STAFF REPORT

APPLICATION NO:	PLAT-2024-03		
HEARING DATE:	October 10, 2024	NEXT HEARING DATE:	November 14, 2024
NEWSPAPER NOTICE PUBLISHED ON:	Unknown	NOTICES MAILED ON:	Unknown
SUBJECT:	Primary Plat review		
LOCATION:	Lapel Industrial Park; East side of SR 13, 950 feet south of SR 38		
PETITIONER(S):	Dorsey Roscoe, CRPP, LLC		
ENGINEER/SURVEYOR:	Mike Deboy, Brent White, Deboy Land Development Services		
SUMMARY:	Commission to consider a Primary Plat for Lapel Industrial Park subdivision containing about 39 acres and proposing 4 lots and two blocks.		
WAIVERS REQUESTED:	None		
RECOMMENDATION:	CONTINUE TO THE NEXT MEETING		
PREPARED BY:	Oksana Polhuy, Planning Administrator		
EXHIBITS:	Exhibit 1. Primary Plat Exhibit 2. Planning and Engineering review letter Exhibit 3. Feasibility Report from the petitioner Exhibit 4. Drainage Approval Exhibit 5. Letters from the Utilities

PLANNING TAC COMMENTS

Comments from: Oksana Polhuy
Application #: PLAT-2024-03
Applicant: Dorsey Roscoe, CRPP, LLC
Surveyor/Engineer: Mike Deboy, Brent White, Deboy Land Development Services
Location: East side of SR 13, 950 feet south of SR 38
Project name: Lapel Industrial Park, Primary Plat
Date: October 3,

P2 OF 5

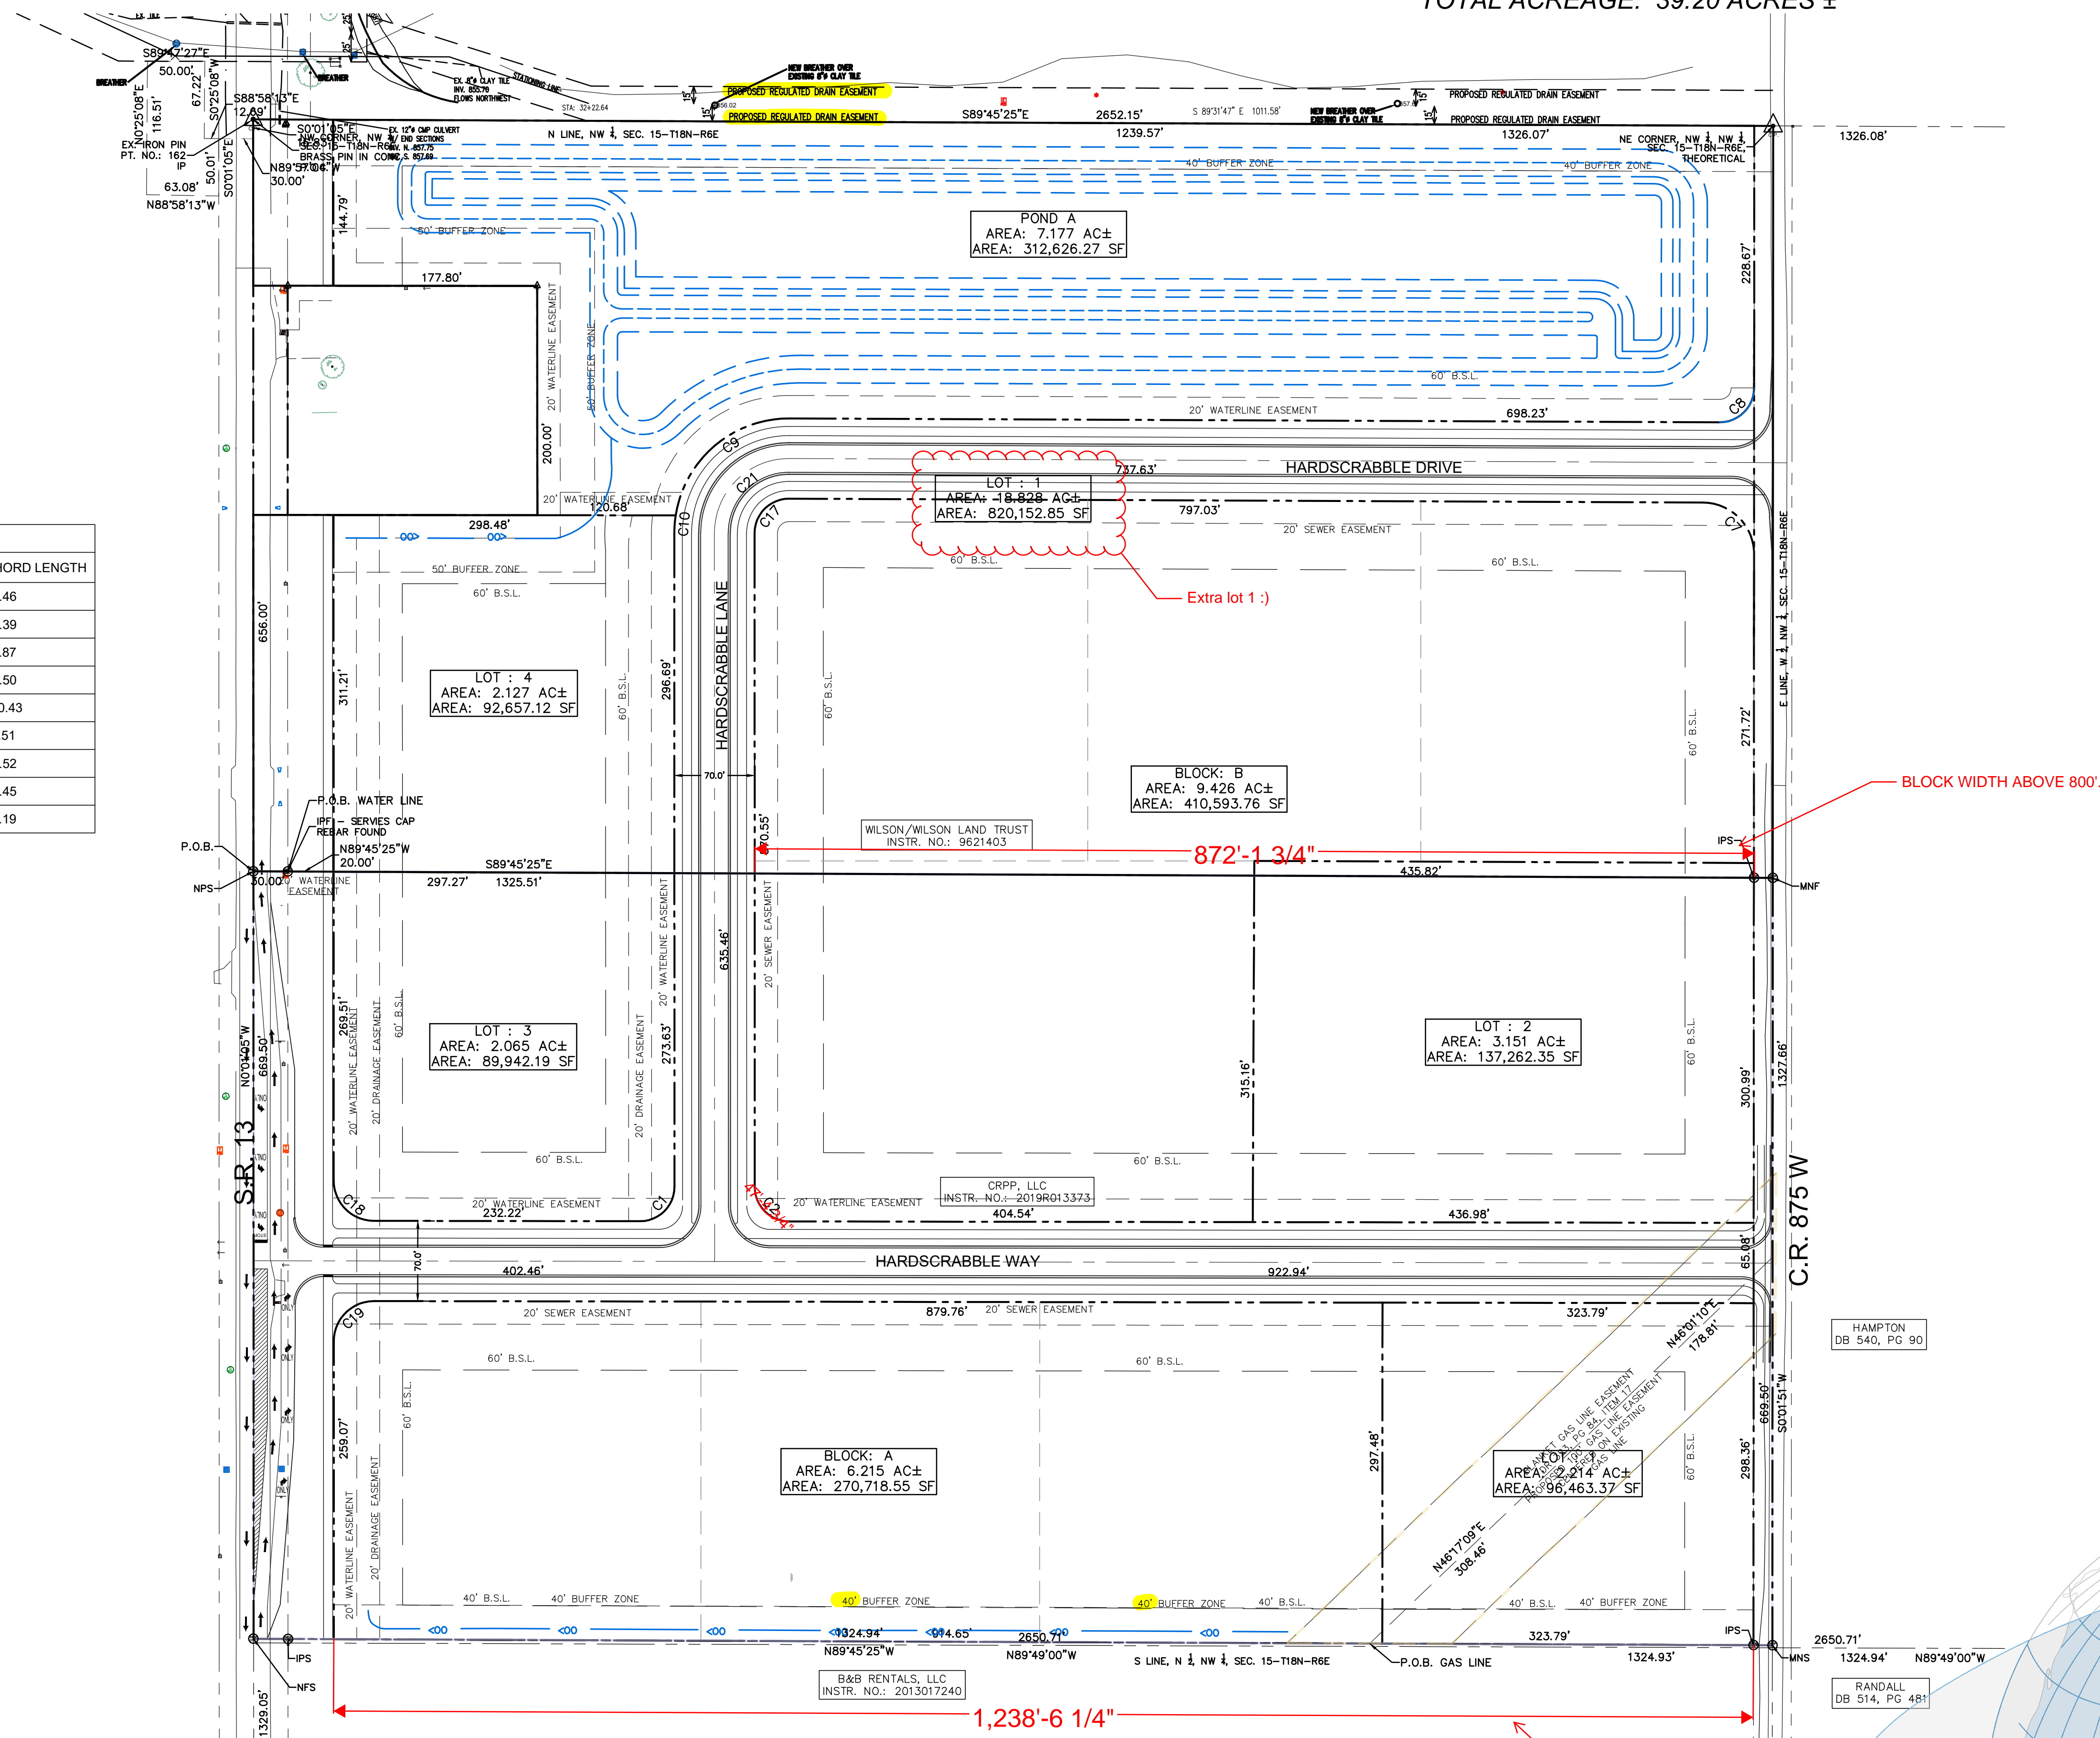
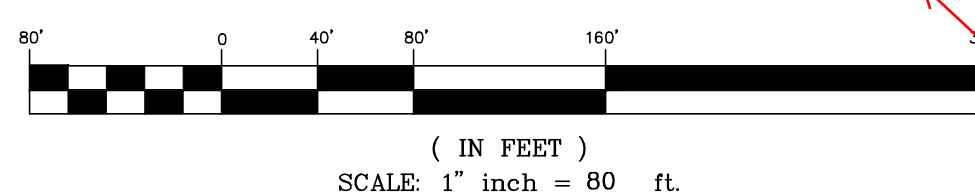
☐ **Block width.** Per UDO V 12.1.6, Block Standards, C, the maximum width of any block is 800 feet. Currently, the following blocks are wider than 800 feet:

- The internal block that contains Block B and Lot 2;
- The block that contains Block A and Lot 1.
- **Block definition:** *"Property abutting on one side of a street and lying between the two (2) nearest intersecting or intercepting streets, intersecting railroad, intersecting waterway, or the end of a dead end street."*

— BLOCK WIDTH ABOVE 800'

P4 OF 5

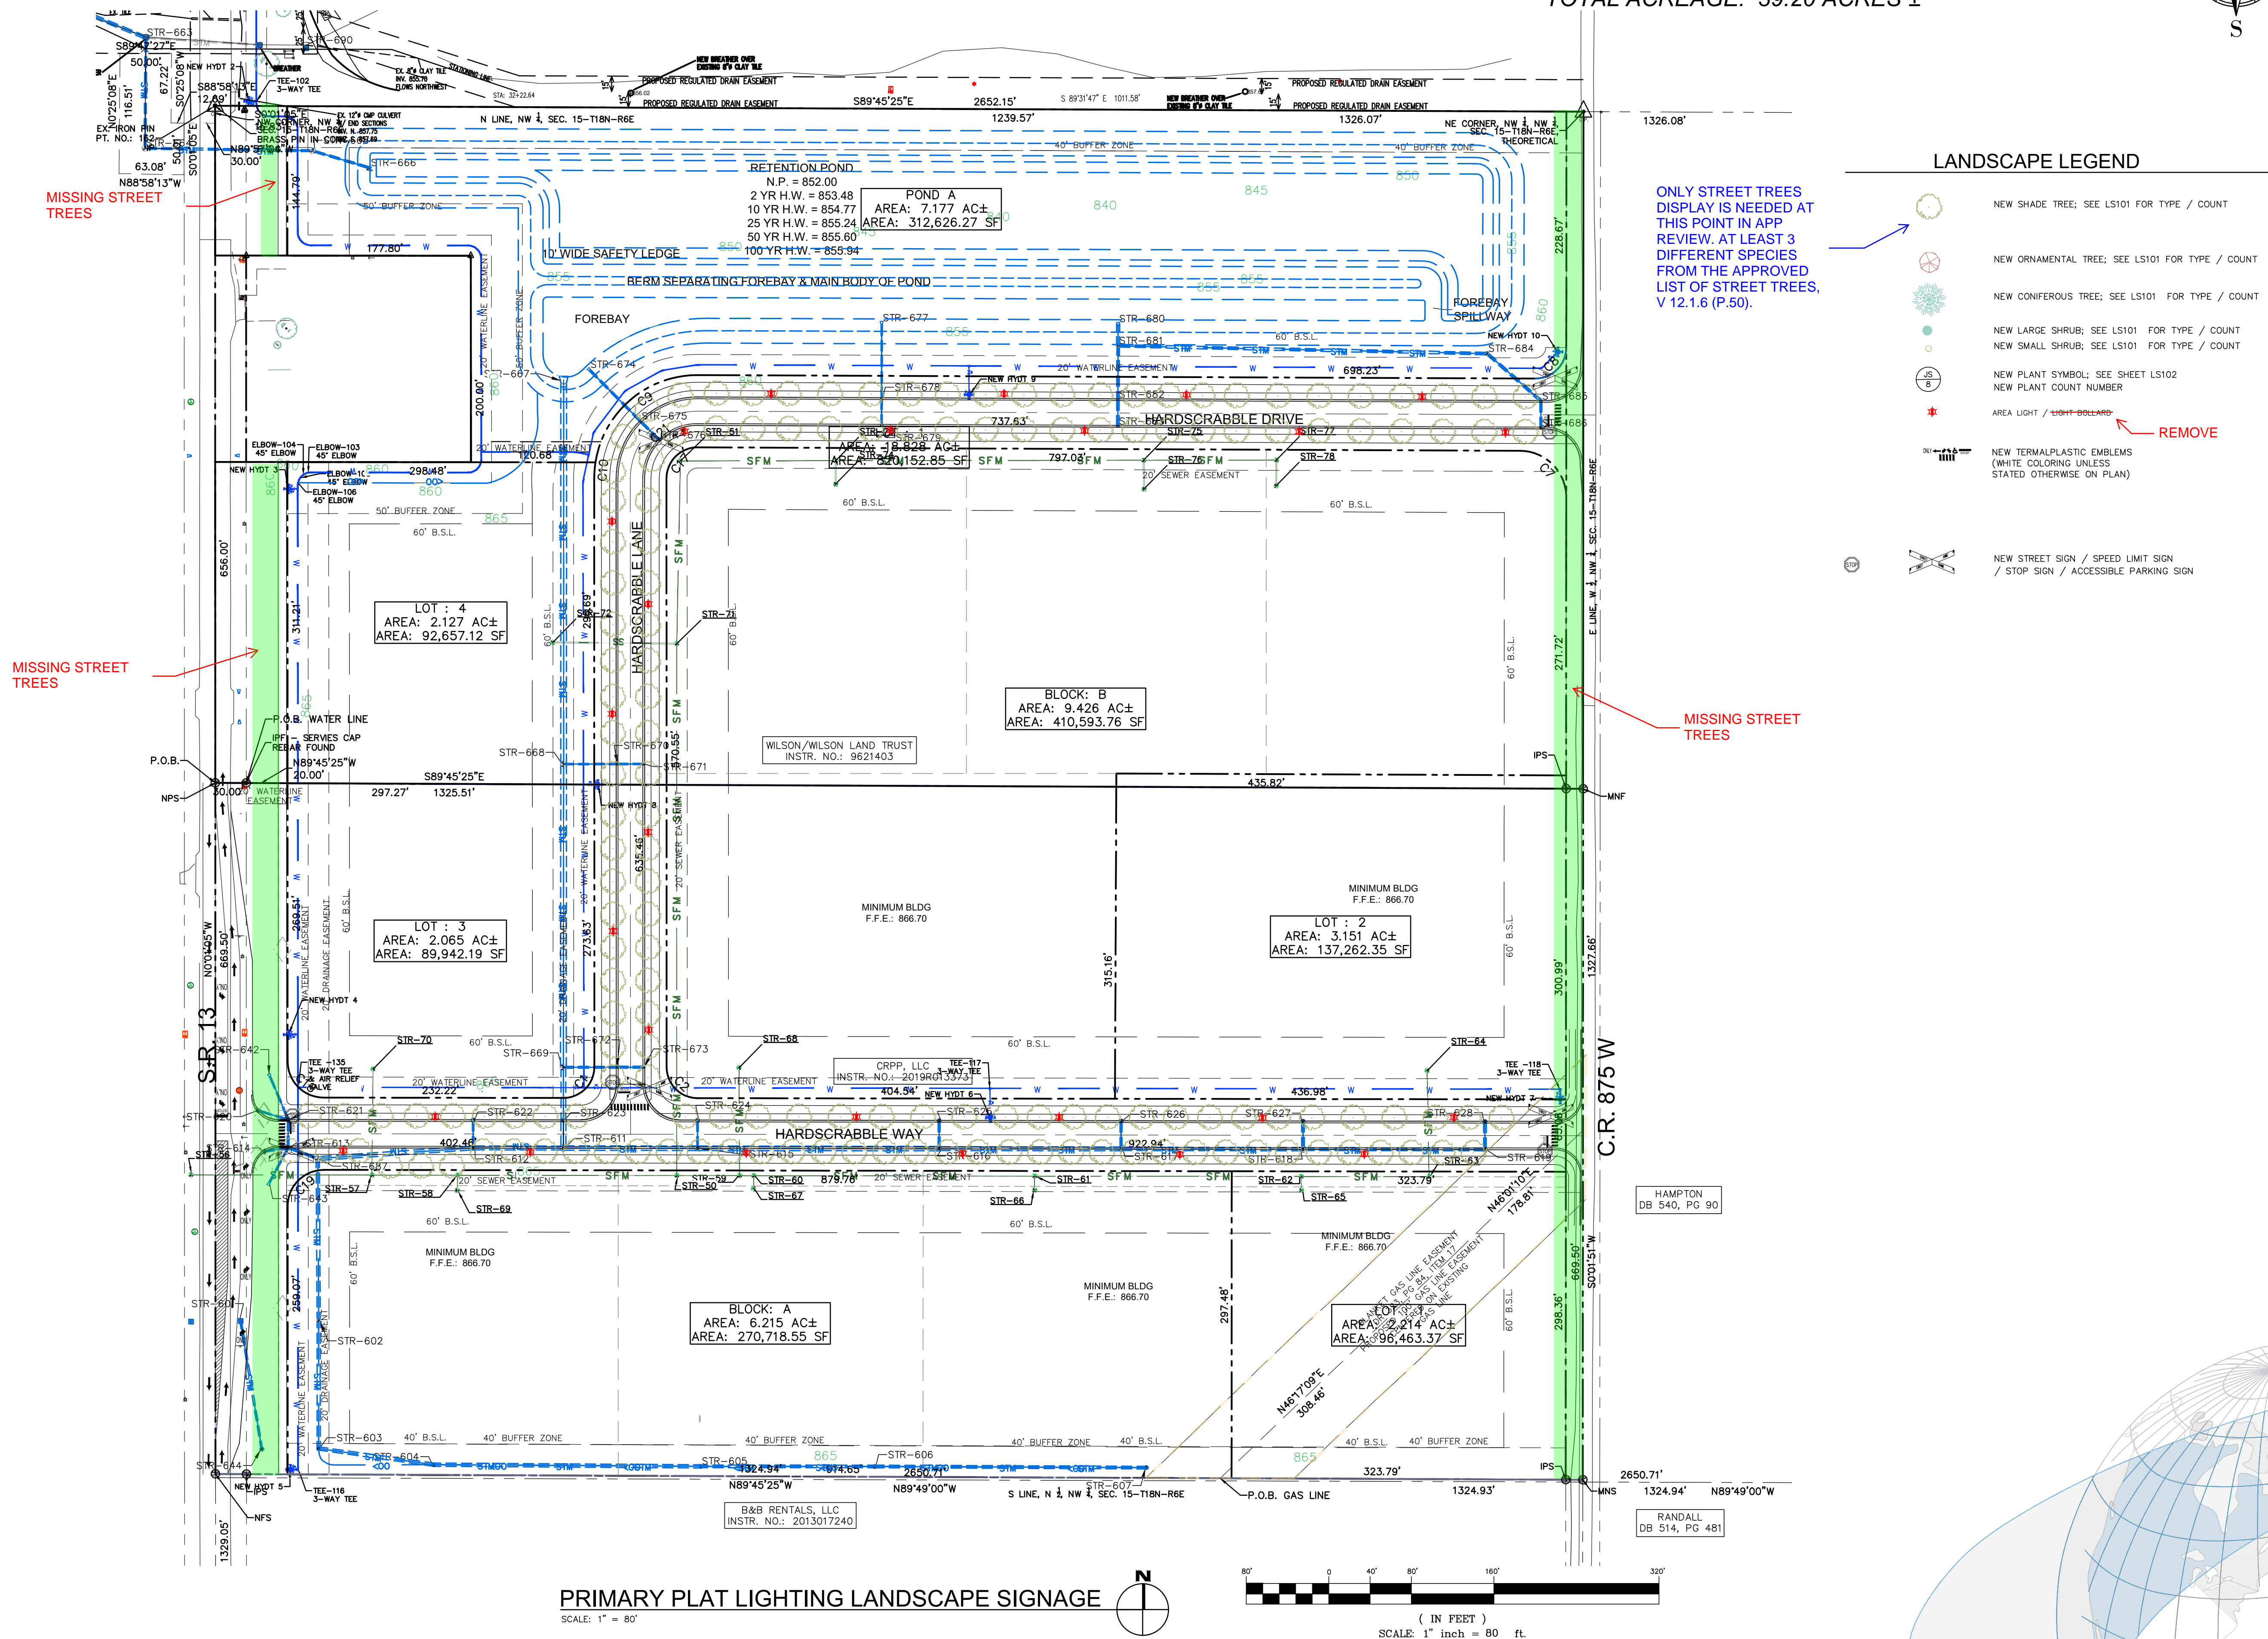
- ☐ **Street Trees.** Street trees should be provided along all streets, including SR 13 and CR 875 W. Please, display those on the landscape plan.
- ☐ **Curbs.** Per UDO V. 12.16, Curb & Gutter Standards, A, the minimum required curb width is 2 feet. The plans note an 18" chairback curb, which doesn't meet the minimum required width. Please, revise the width. Note, that the width of this curb is then included into the total street pavement width of 28 feet.
